INCORRECT LOCATION of SHIFT CABLE ANCHOR STUDS on MCM 888 and 233

(Attach Bulletin Reference Sticker to P. 2B-8 of Your Service Manual.)

Figure 1. Shift Bracket Assembly (Removed from Engine for Clarity)

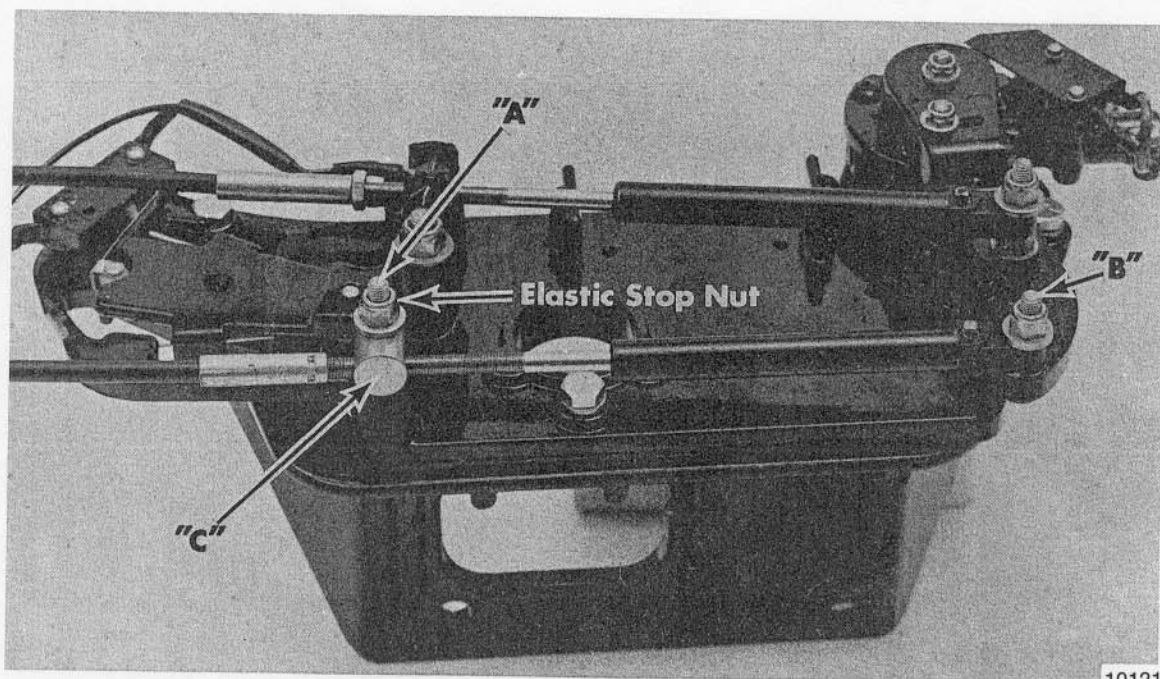
On some MCM 888 and 233 transom plate assemblies, shift cable anchor studs "A" and "B", shown in Figure 1, were installed in the wrong location on the shift bracket assembly, with the result that stud "A" is too short. It will not extend thru the elastic stop nut (shown) when shift cable brass barrel "C" is installed. At least four (4) threads of stud must be exposed through nut. Studs "A" and "B" MUST BE reversed, or stud "A" only must be replaced, to ensure correct stud extension thru the elastic stop nut.

A stud remover or vise grip pliers and heat will be required to remove studs, as studs are secured in place with Loctite.

Stud "A": Part No. 16-47360

Stud "B": Part No. 16-63081
